Report Nos.: 50-280/94-16 and 50-281/94-16

Facility Name: Surry Power Station Units 1 and 2

Inspection Conducted: June 20-24, 1994

Figure 1

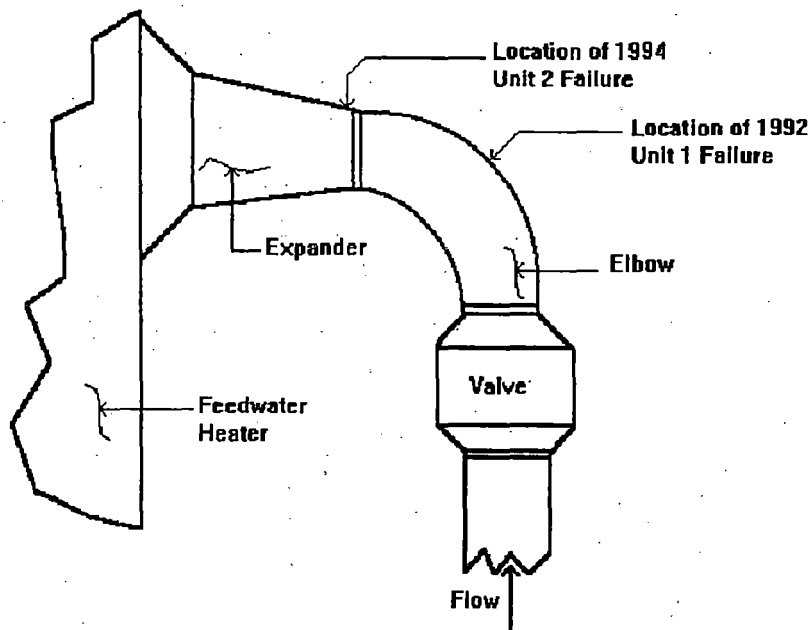
In 1992, prior to the implementation of the CHECMATE® program, the licensee ultrasonically examined the elbow and expander on the Unit 1 "B" train line (in the same relative position as above). The minimum wall thickness value found, though acceptable then, would have been unacceptable prior to the end of the next fuel cycle. The maximum point of wear was approximately 16" to 20" down the extrados of the elbow at the 12:00 position (see Figure 1).

The licensee expanded the sample and examined the "A" train elbow and expander. They were found to be acceptable for continued service. The

Unit 1 "B" train elbow was replaced with a low alloy steel, 2½Cr 1Mo, fitting. The Unit 1 "B" train expander remains the original carbon steel.
